*PLANS FOR THE CONSTRUCTION OF
SEDIMENT REMOVAL
FOR
VITRUVIAN PARK
TOWN OF ADDISON, TEXAS
PUBLIC WORKS #19-77*

VITRUVIAN PARK
 DREDGING
 TOWN OF ADDISON
 DALLAS COUNTY, TEXAS

revisions	date
1 ADDENDUM 3	2/20/2019

MAIN CHANNEL CROSS SECTIONS				
design	drawn	checked	scale	date
NDM	NDM	NDM	NDM	2/20/19

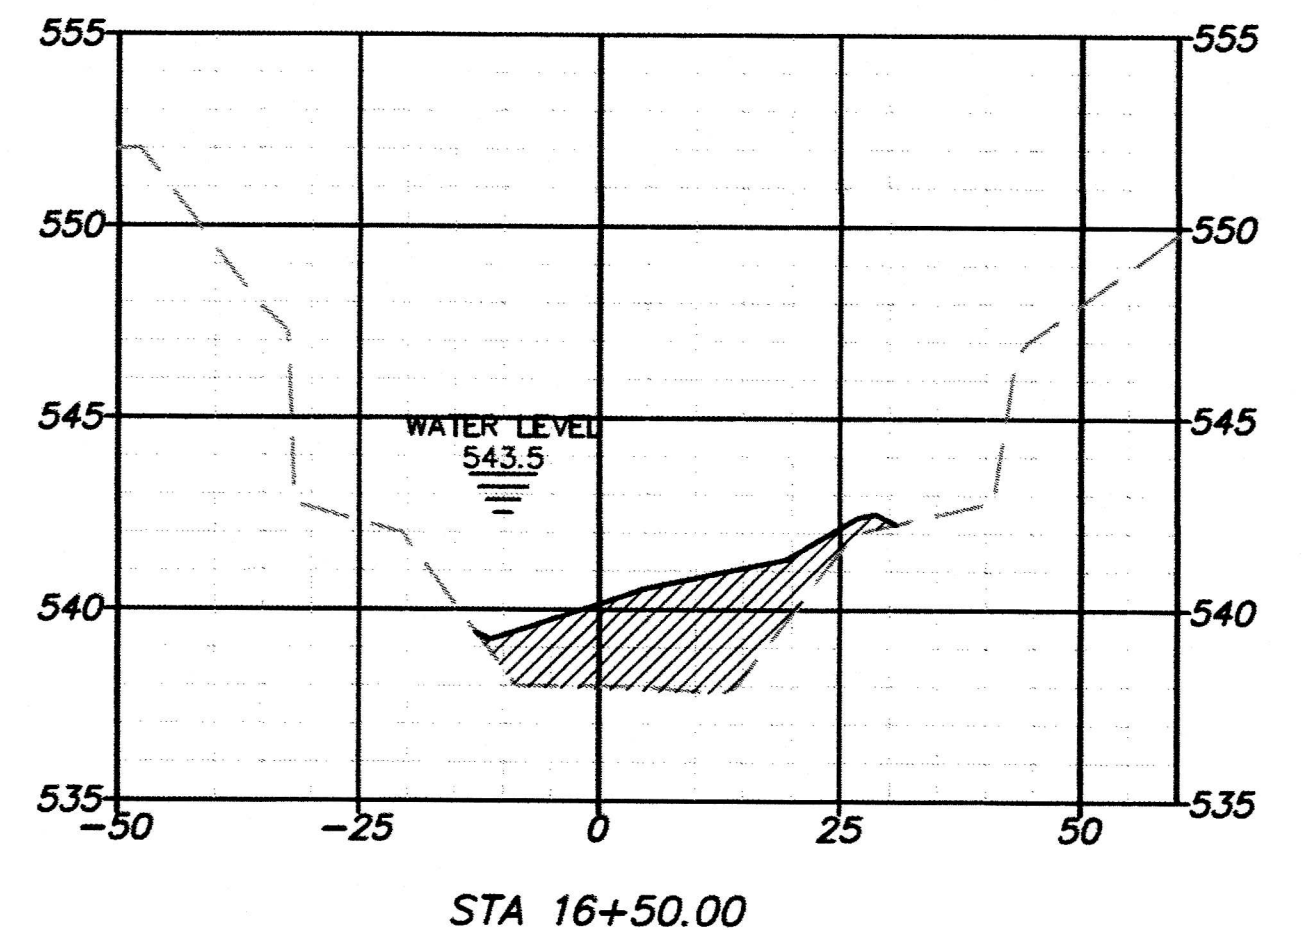
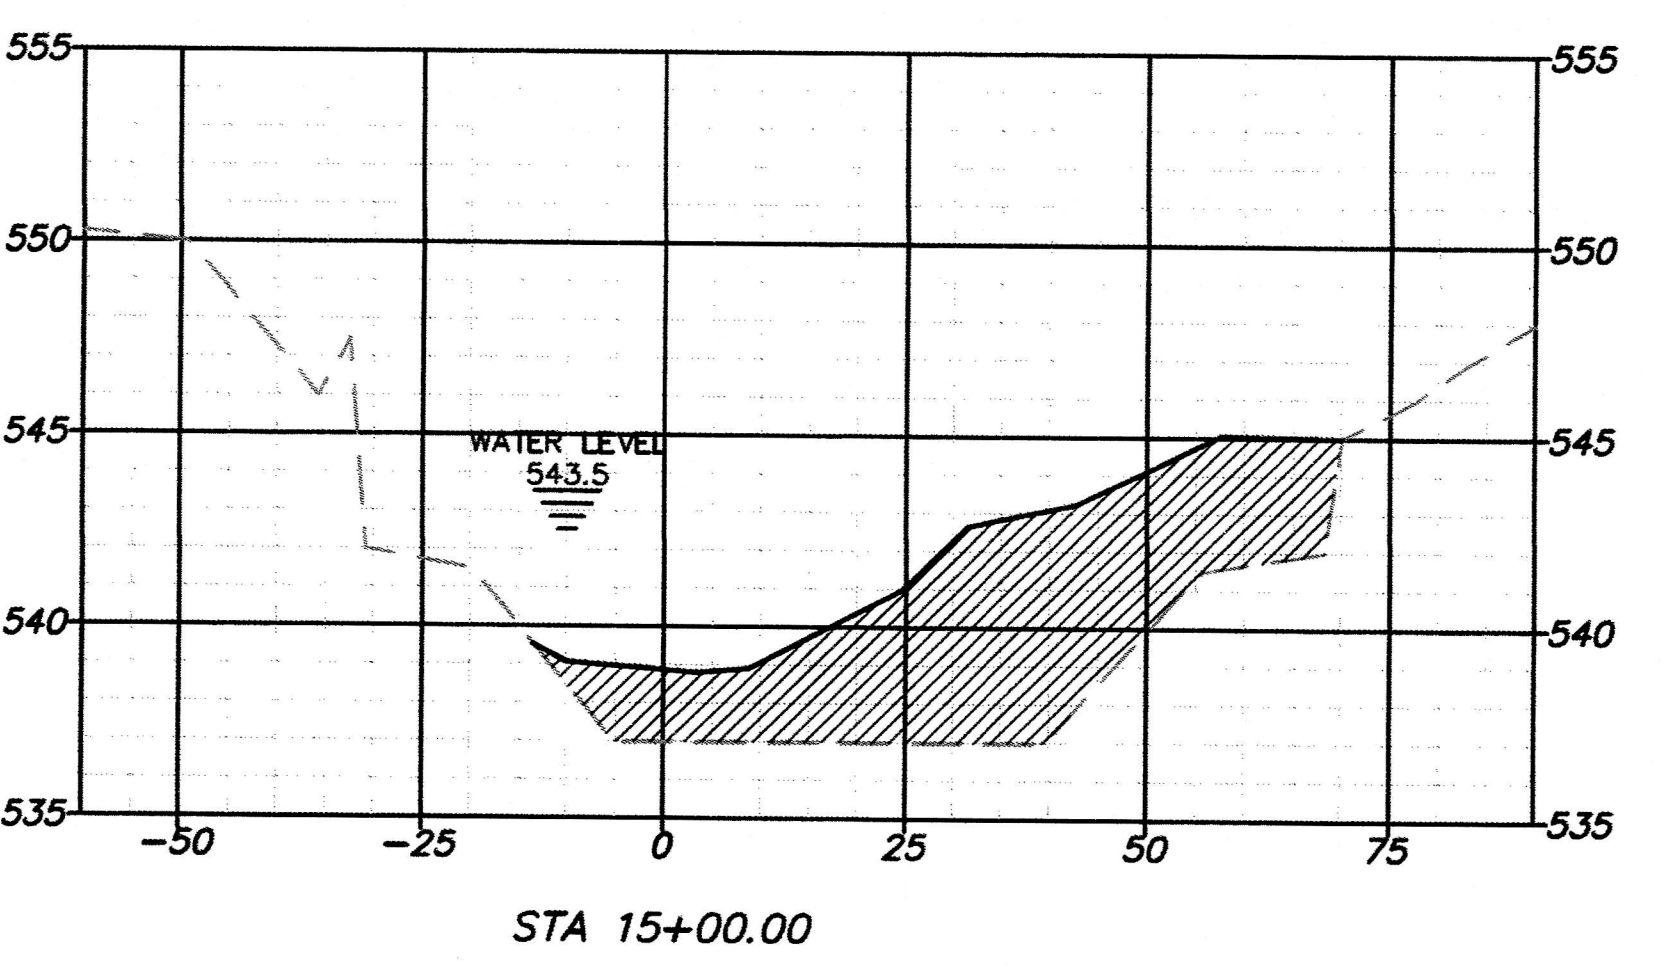
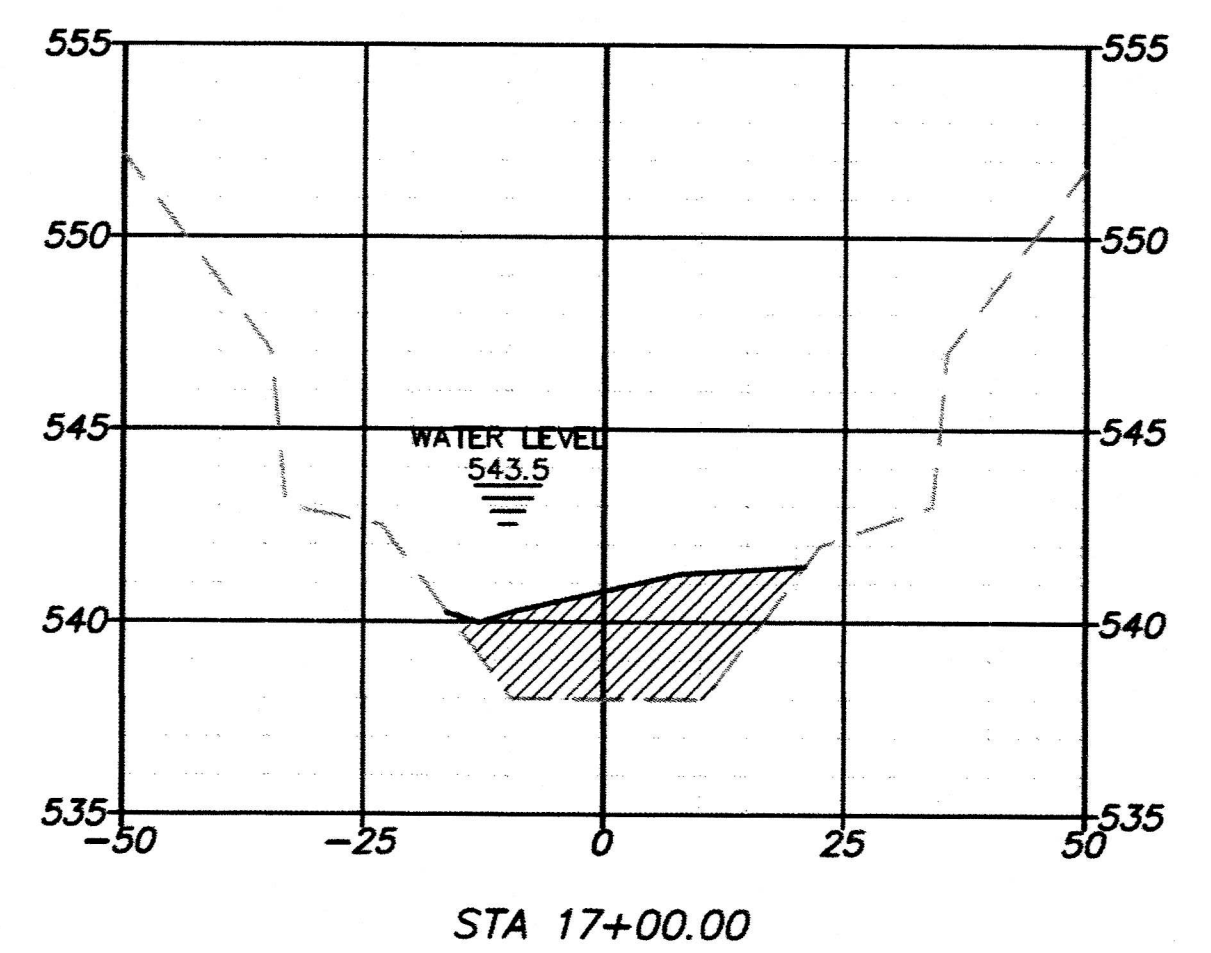
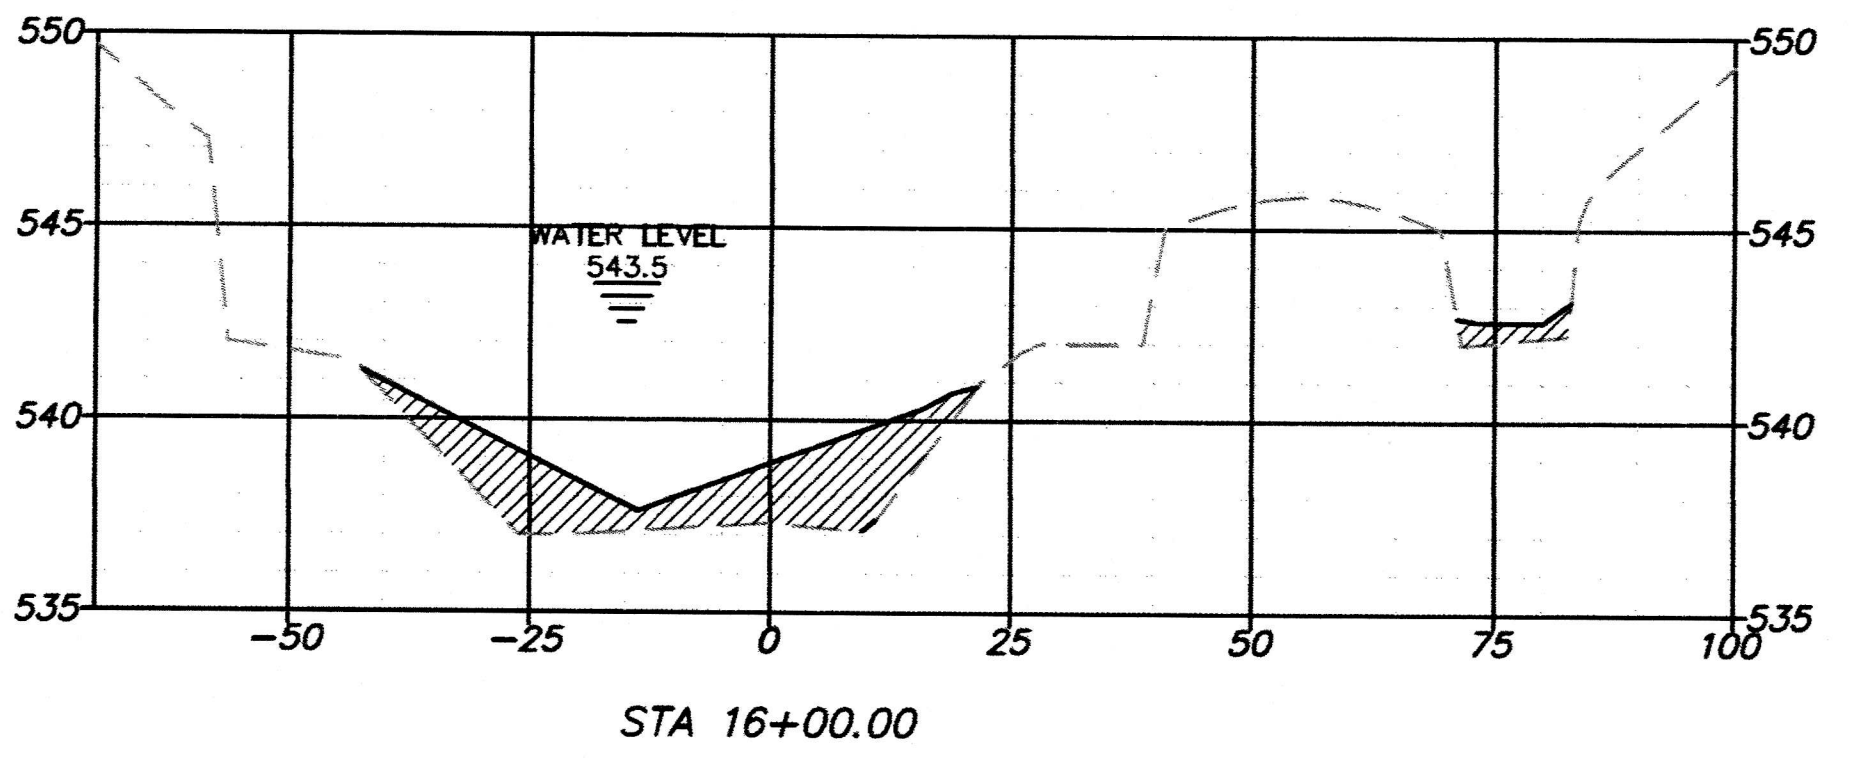
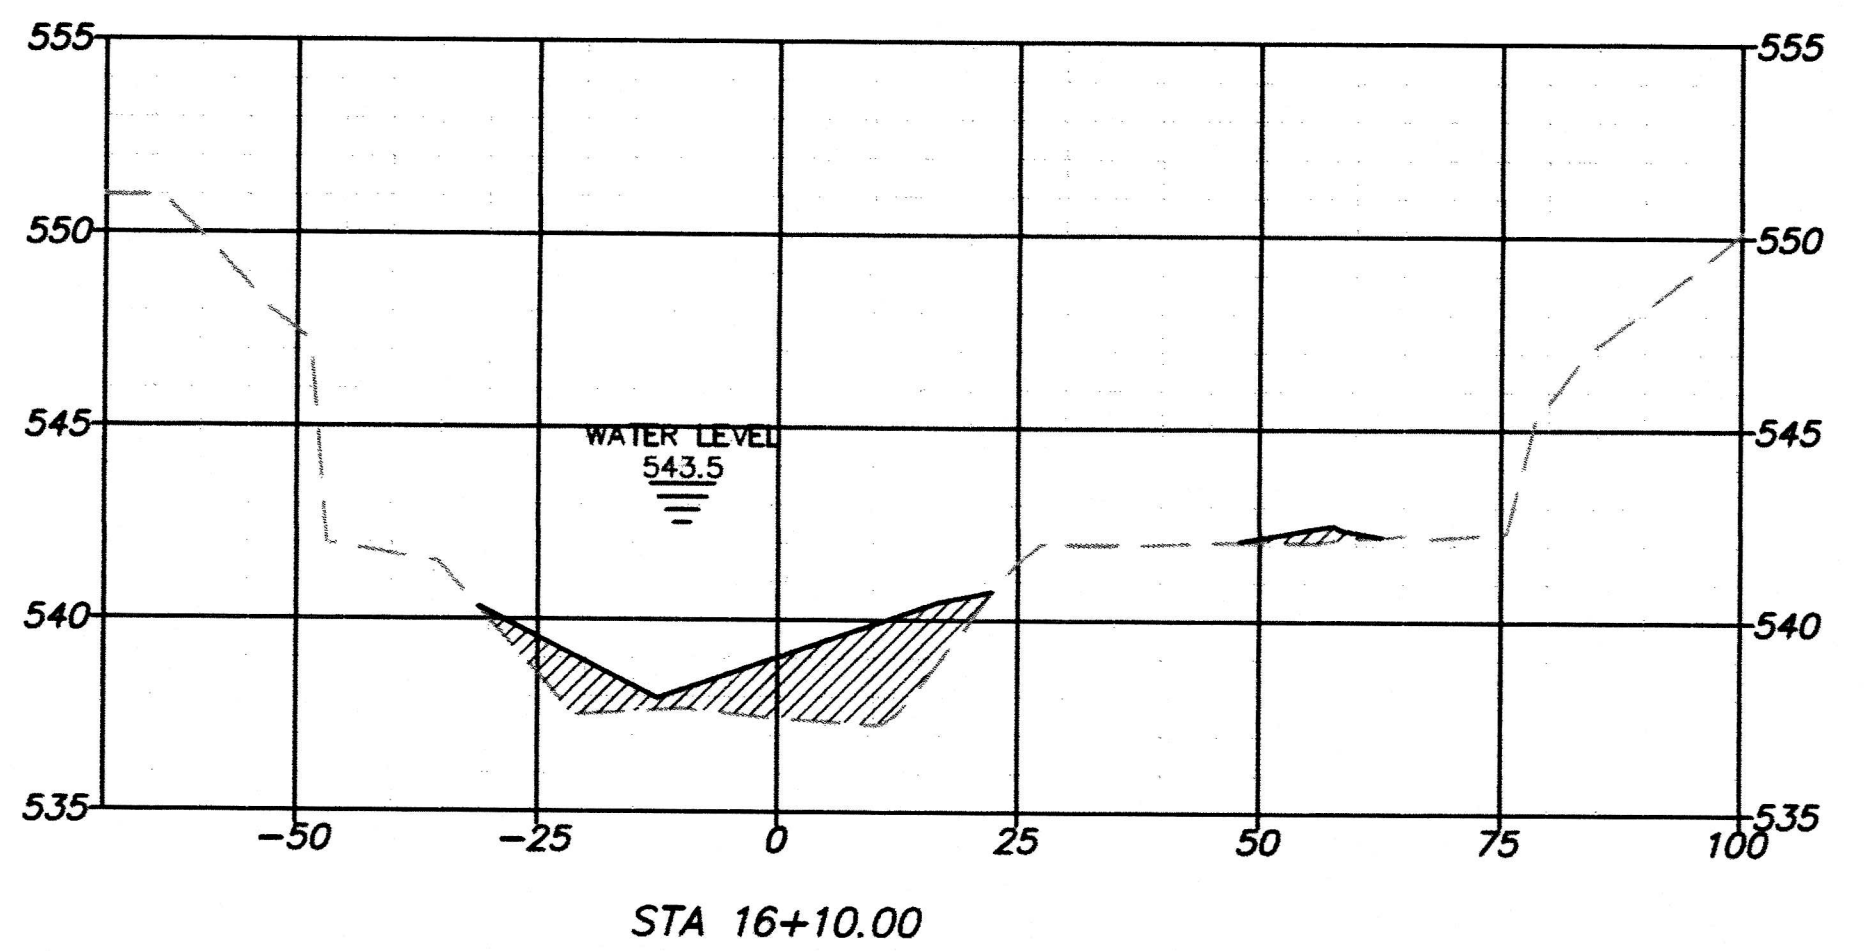
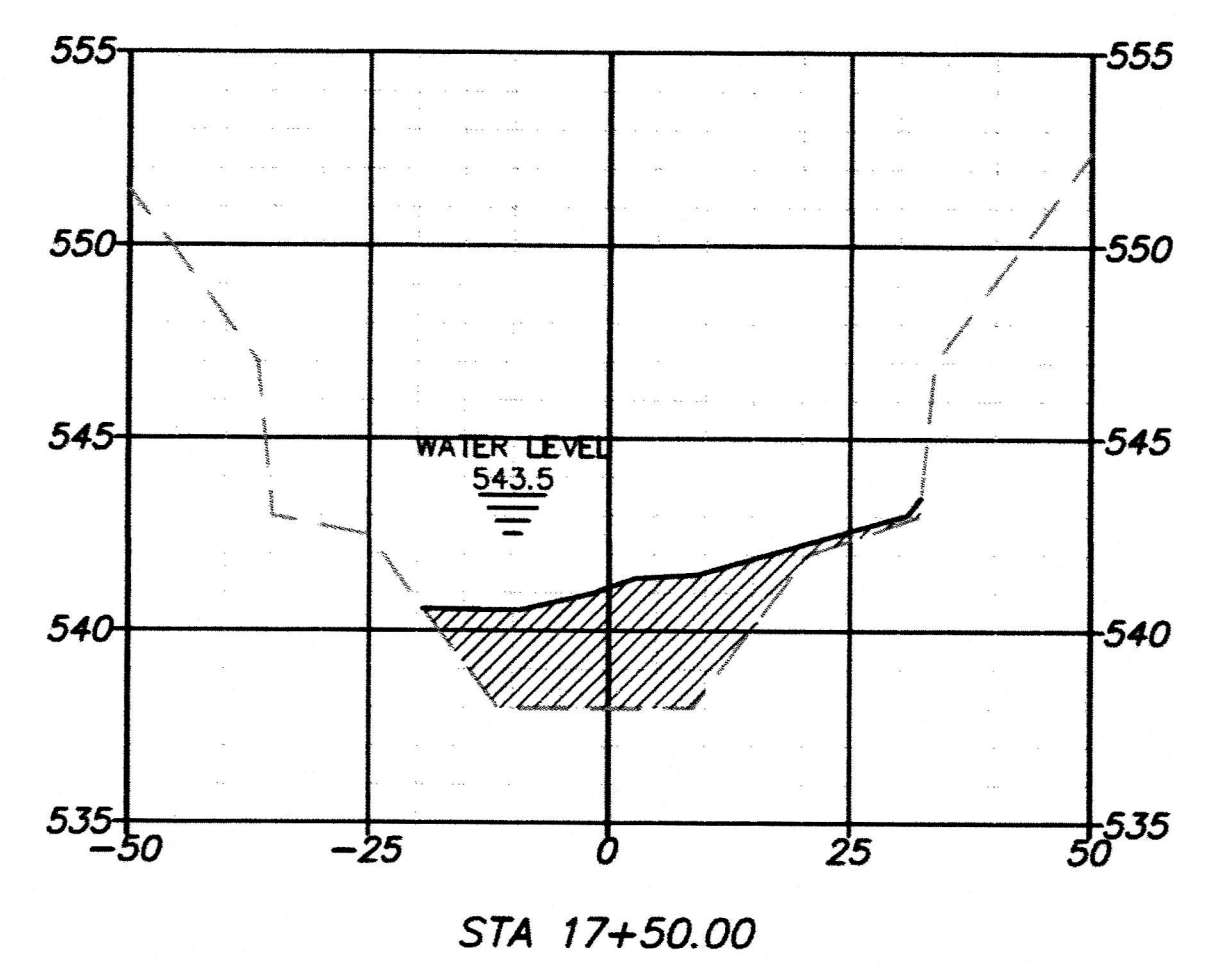
▲ WATER SURFACE ADDED BASED ON SURVEY OF 2/18/2019.

MAIN CHANNEL CROSS SECTIONS				
design	drawn	checked	scale	date
NDM	NDM	NDM	NDM	2/20/19

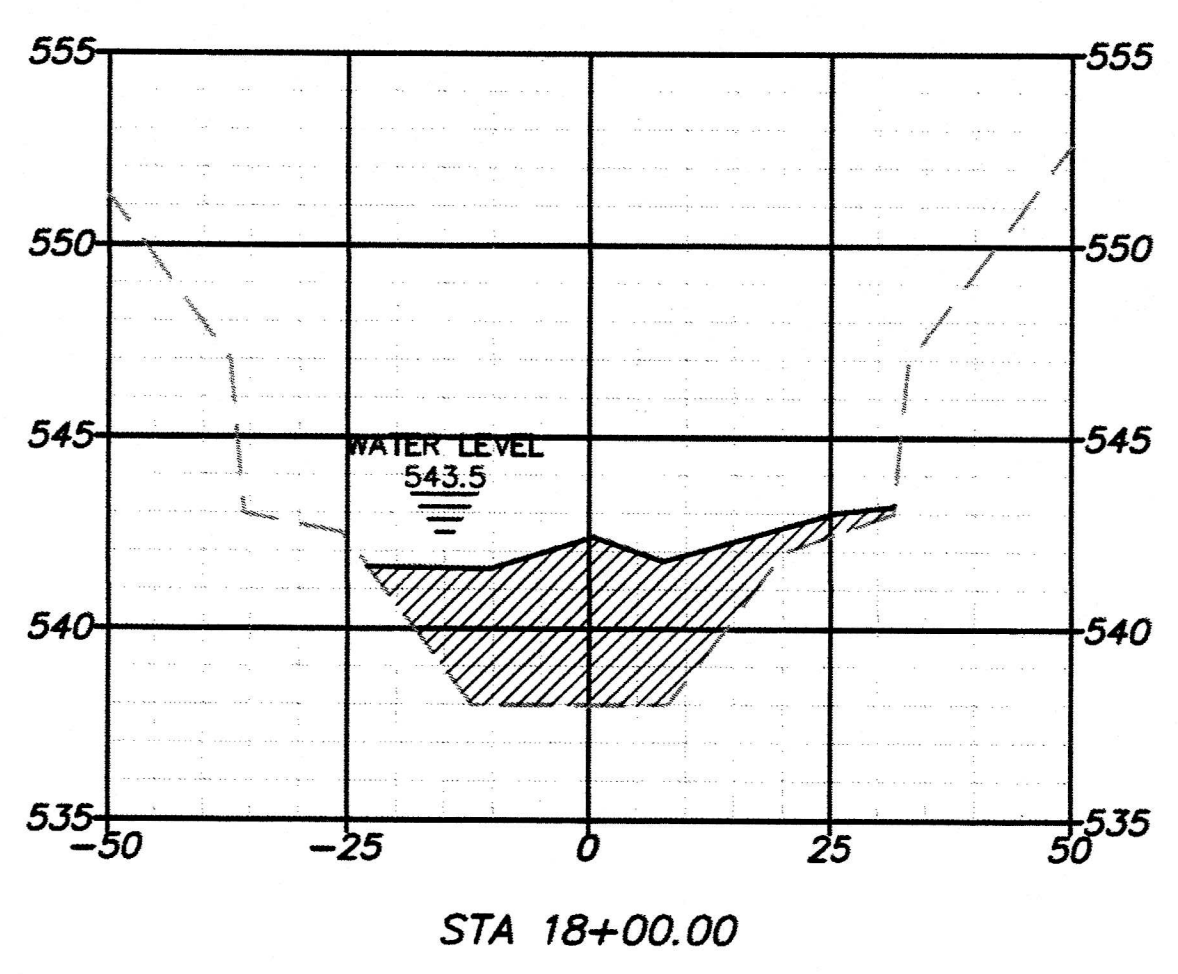
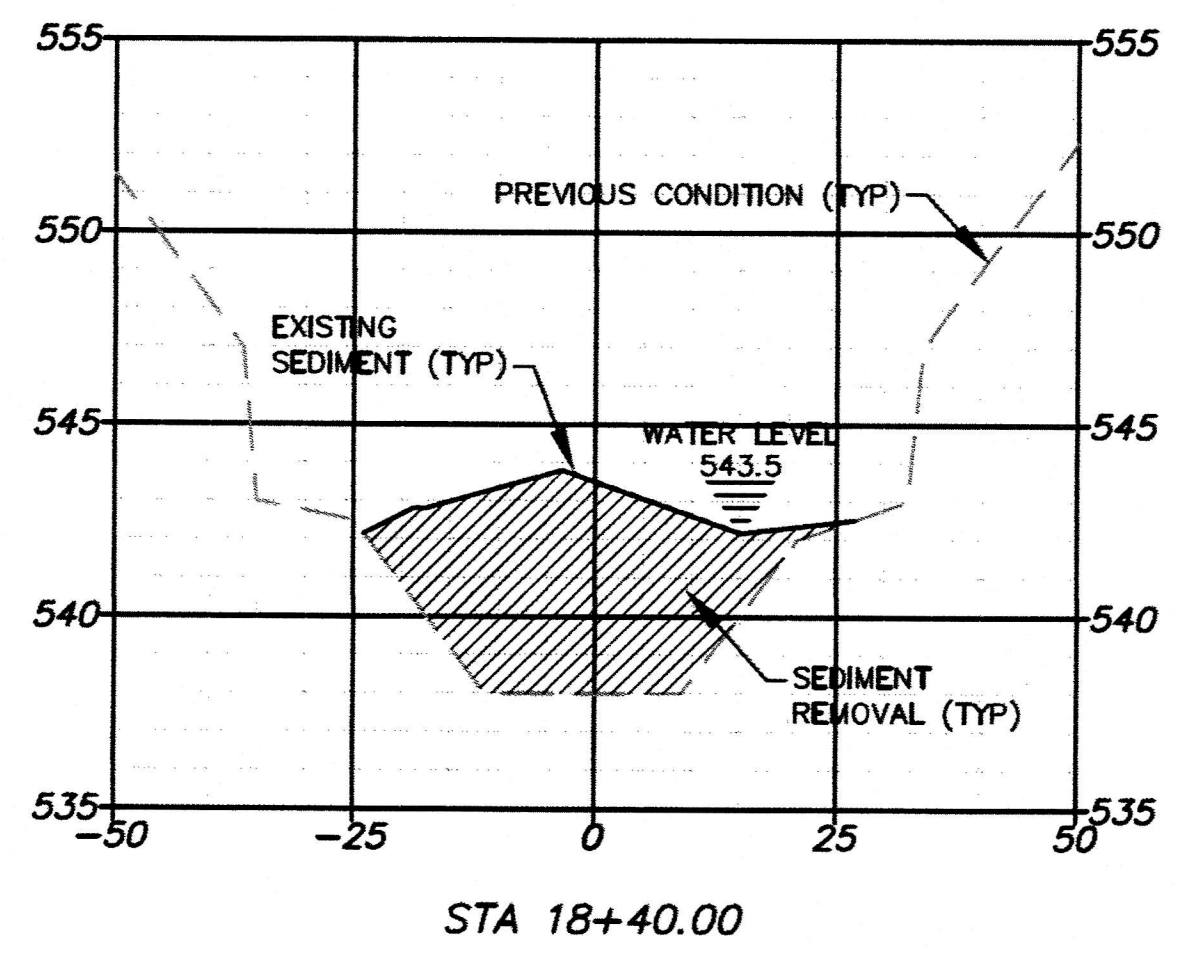
▲ WATER SURFACE ADDED BASED ON SURVEY OF 2/18/2019.
